## Appendix to ED Decision 2018/008/R

RELATED NPA: 2017-11 — RMT.0456 (RMT.0621, RMT.0622) — 27.8.2018

## 2. Individual comments and responses

Attachment #1 to comment [#71](#)

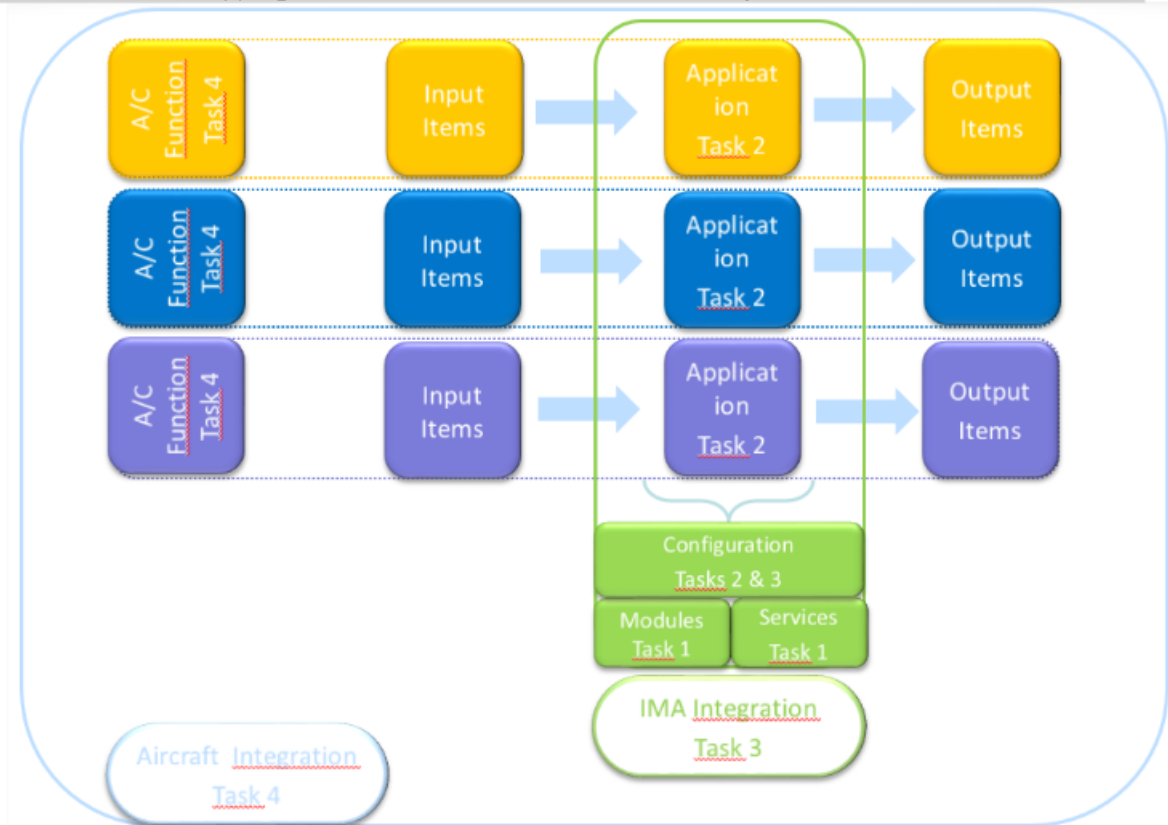
Replace figure 4 of NPA 2017-11 with figure 4 of ED-124.

<p>In order to harmonize with EUROCAE ED-124 / RTCA DO-297, it would be better if figure 4 of NPA 2017-11 could be replaced with figure 4 of ED-124.</p> <p><b>Proposed change:</b></p> <p>The original text:</p> <p><i>"Figure 4 illustrates a mapping between the architecture of an IMA system and Tasks 1 to 4 of ED-124:</i>  <u>See annex 1</u>  <i>Figure 4 – Breakdown of an IMA system and mapping to ED-124 tasks"</i></p> <p>Should be changed to:</p> <p><i>"Figure 4 illustrates the system certification tasks of ED-124:</i>  <u>See annex 2</u>  <i>Figure 4 – IMA system certification tasks illustration</i></p>

response	<p>Partially accepted.</p> <p>EASA does not consider that Figure 4 of ED-124 is equivalent, as it does not adequately highlight the breakdown per system function (ATA) and the 'matrix' of A/C functions versus tasks.</p> <p>Nevertheless, EASA agrees that the text could be clarified, and proposes to reword it as follows:</p> <p>'Figure 4 illustrates a mapping between an IMA system breakdown and the certification tasks of ED-124:</p> <p>Figure 4 — Mapping between an IMA system and the ED-124 certification tasks'</p>
